No. EL/3.2.13/1

MODIFICATION SHEET NO. ELRS/MS/ 0282, Rev. '0' - 2000

Provision of modified sanding pipe arrangement for WAP1/4 class of Electric Locomotives.

8.0 MODIFICATION DRAWING : RDSO's Drg. No. SKEL4562, Alt. '0'.

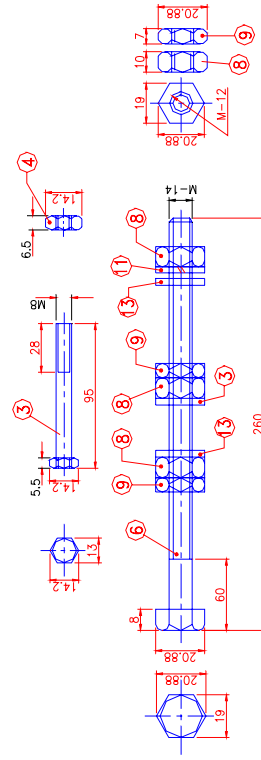
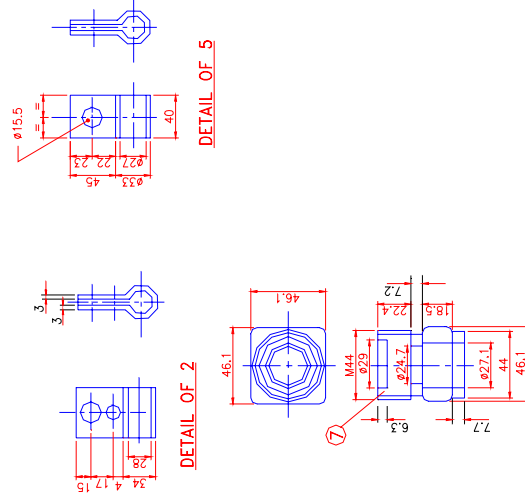
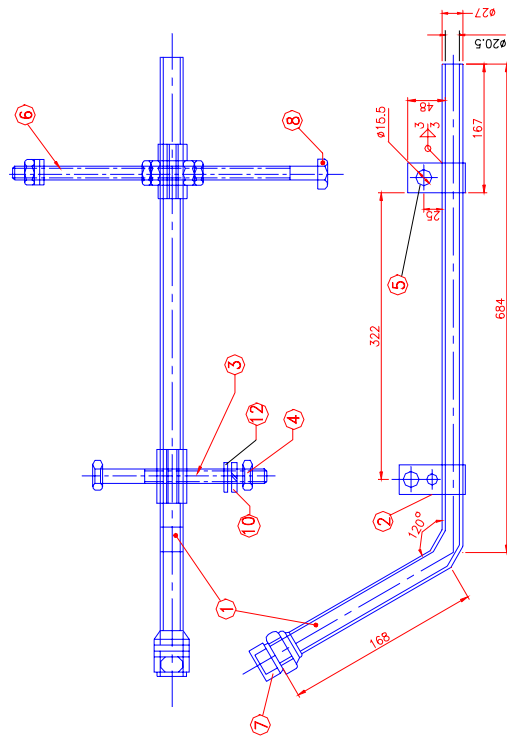
Existing arrangement of sanding pipe in flexi-coil mark-I bogies being used in WAP1/4 class of Electric Locomotives has following problems ;

- More weight.
- Lesser height from the rail top.
- Sanding hose remains in tension.

As a result, it has been Railways' experience that cases of sander bracket/sander pipe getting broken/dropped due to cattle run over are too many in number. During co-ordination meeting held recently with CLW & Railways at Electric Loco Shed/Kanpur on 27.4.2000, a modified design of sander pipe was demonstrated by Kanpur Shed which has been successfully tried on all the WAP class of Electric Locomotives and has been working satisfactorily from last six months. Electric Loco Shed/Jhansi have also confirmed that they had also started using similar arrangement and it is giving good performance. It was, therefore, decided to use this modified arrangement on all flexi-coil mark-I bogies of WAP1/4 class of Electric Locomotives.

The modified drawing of sanding pipe is to be adopted as per RDSO's Drg. No. SKEL 4562, Alt. '0'.

Sanding pipe as per RDSO's Drg. No. SKEL4562, Alt. '0'.
